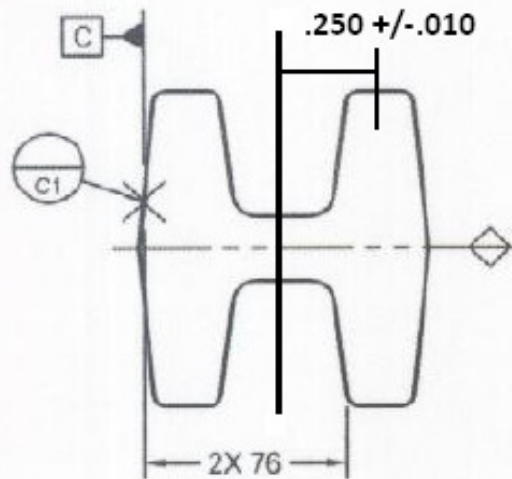
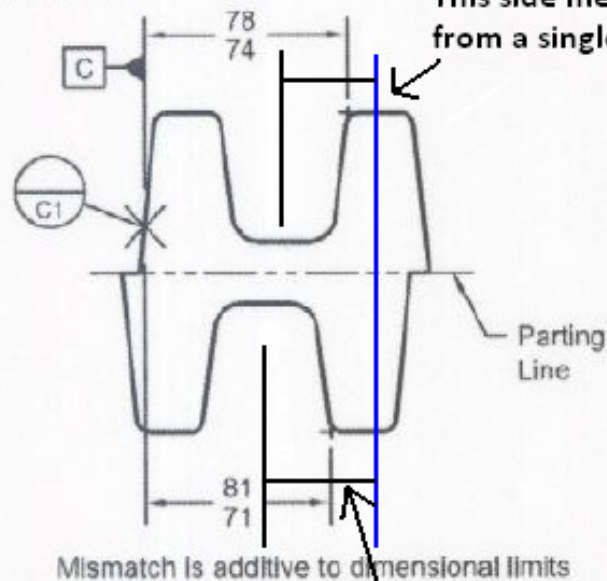
This side meets the .250, since this is made from a single forging die

Mismatch is additive to dimensional limits

This side however is out, but in terms of parting line dimension, is ok???
